CITY OF CONWAY, ARKANSAS HISTORIC DISTRICT COMMISSION

2022 & 2024 Weems Street - New Single-Family Construction (2)

1925 Cross Street - Carport Enclosure

Lot-269C Replat
#2022 WEEMS STREET

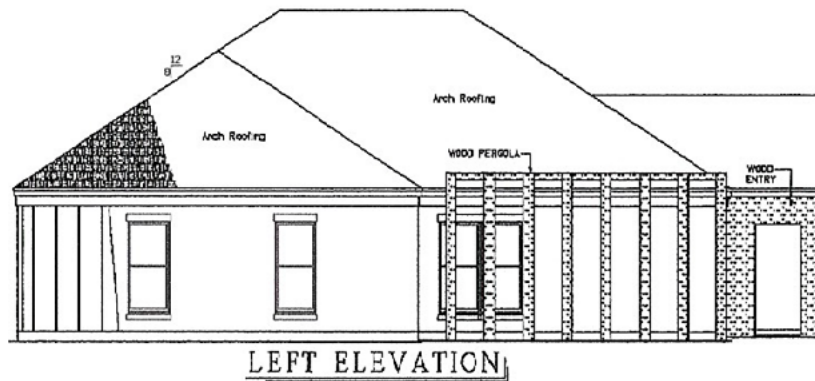
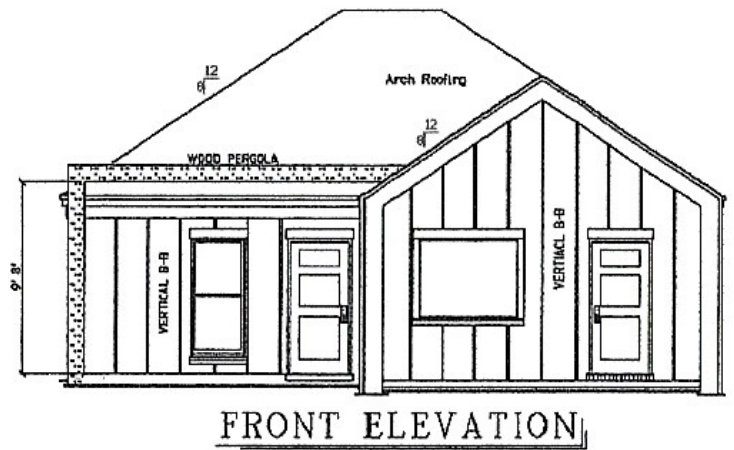
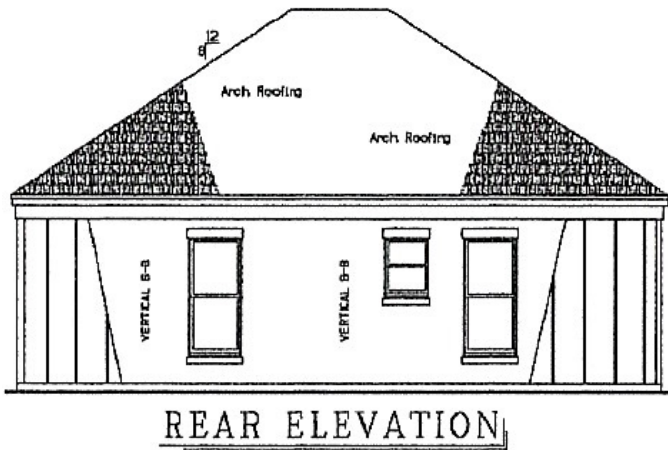
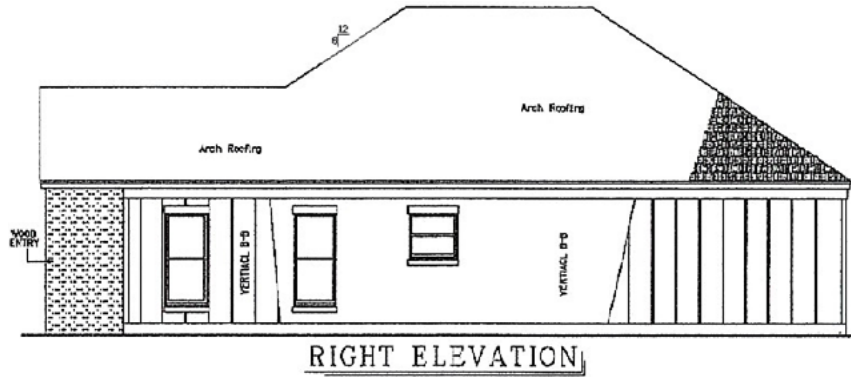
The design of 2024 Weems (west) appears to be generally compatible in design with the surrounding area using traditional forms and patterns. The design of 2022 Weems (east) does not appear compatible with the surrounding area with a design that appears generally more modern (non-traditional porch form) and roof form mimicking suburban form houses.

An open front porch with a 6' depth is proposed for 2024 Weems (west) with 5' for 2022 Weems (east). Regulations require at least a 6' depth porch. The use of a pergola for a porch on 2024 Weems (west) is not compatible with the general area, given the use of a recessed entry.

Applicant is recommended to consider using an English Revival style "swoop" transition between the main gable and porch. The porch form for 2022 Weems (east) is not compatible with the general area.

The applicant is proposing a variety of roof forms for the houses. This roof forms for 2024 Weems (west) appear compatible. The hip roof form for 2022 Weems (east) gives the structure a more suburban appearance that is not compatible to the district.

Staff recommends tabling the application to allow the applicant to submit additional information on driveways, sidewalks, and walkways as well as correct architectural elevations to provide designs compatible with the regulations and general area.

2024 Weems Street

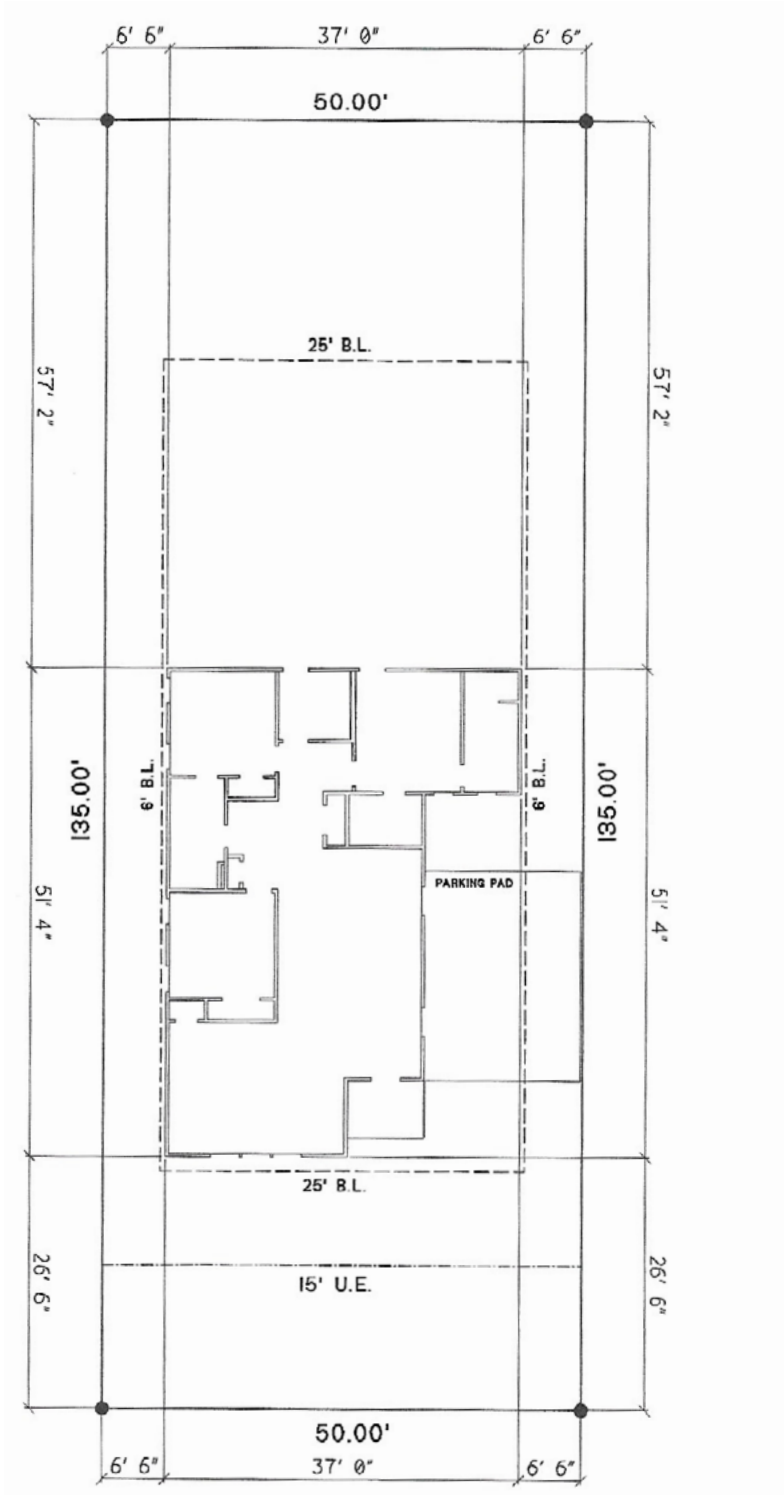
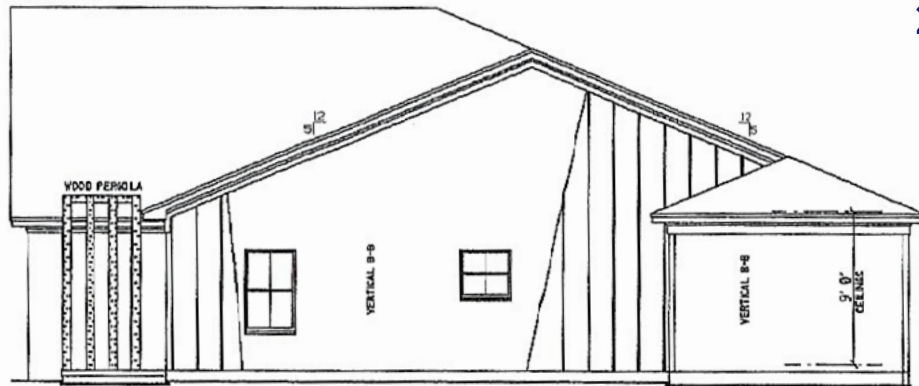
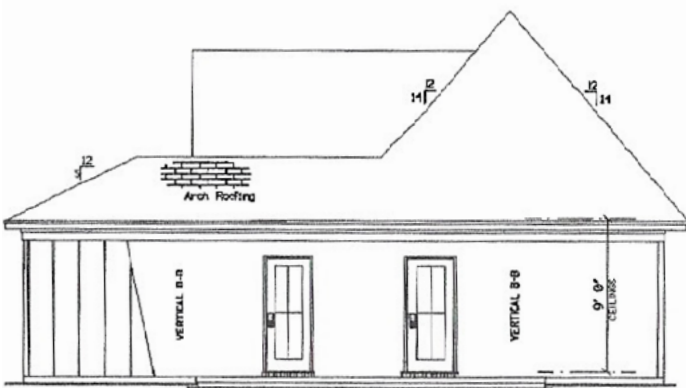
The applicant has not indicated driveways on the plans. The applicant has indicated 15' wide parking pads for both lots. 2024 Weems (west) features a parking pad placed directly on the property line. 2022 Weems (east) features a partially covered parking pad under a wooden pergola. The plans cannot be adequately evaluated due to a lack of information on the plans for driveways.

The applicant is proposing board and batten siding for both structures. Recommend limiting the use of board and batten to one structure and require lap siding for one of the structures.

The slab construction of the foundation does not appear to have a compatible appearance. Recommend requiring a crawlspace or a taller slab to have a more compatible appearance.
